09 - 2011
BDF454 / BDF454Z / BDF454F
18V 1/2" CORDLESS DRIVER DRILL

SERVICE CHANGES

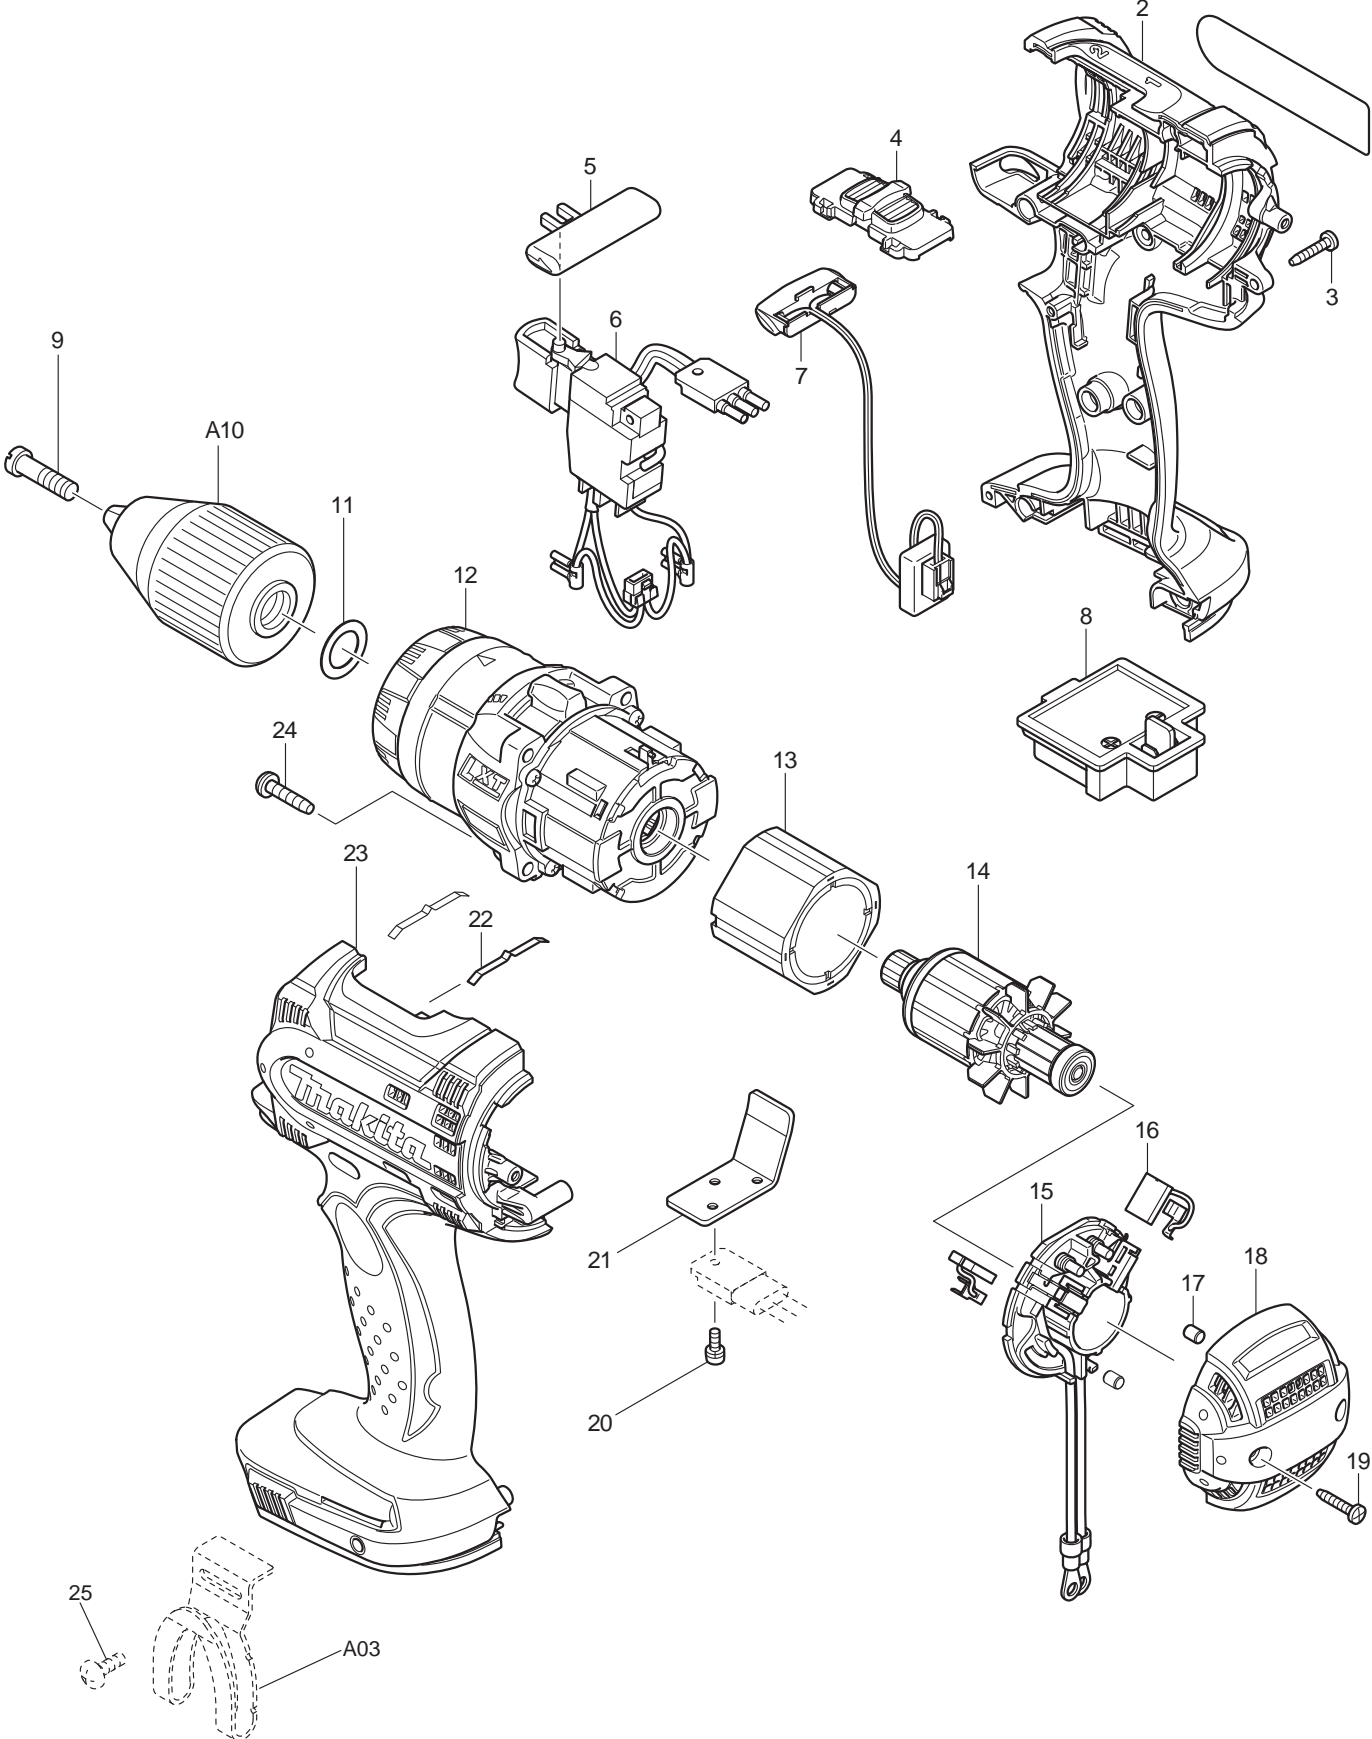
1. Changes on Switch, Terminal, and Housing Set (Battery Protection Circuit)

Item No.	Description	Type 1	Type 2	Type 3
2	HOUSING SET		188525-5	187356-9
6	SWITCH		650573-9	650693-9
8	TERMINAL	643812-4	643838-6	643859-8

Above parts are completely interchangeable as a set.

- Use new parts for repair of the model manufactured on or after March 2012 with using Yellow lead wire between Switch and Terminal.
- Use current parts for repair of the model manufactured before March 2012 without using Yellow lead wire between Switch and Terminal.

*** See Technical Information No. 94114 for Wiring changes.**
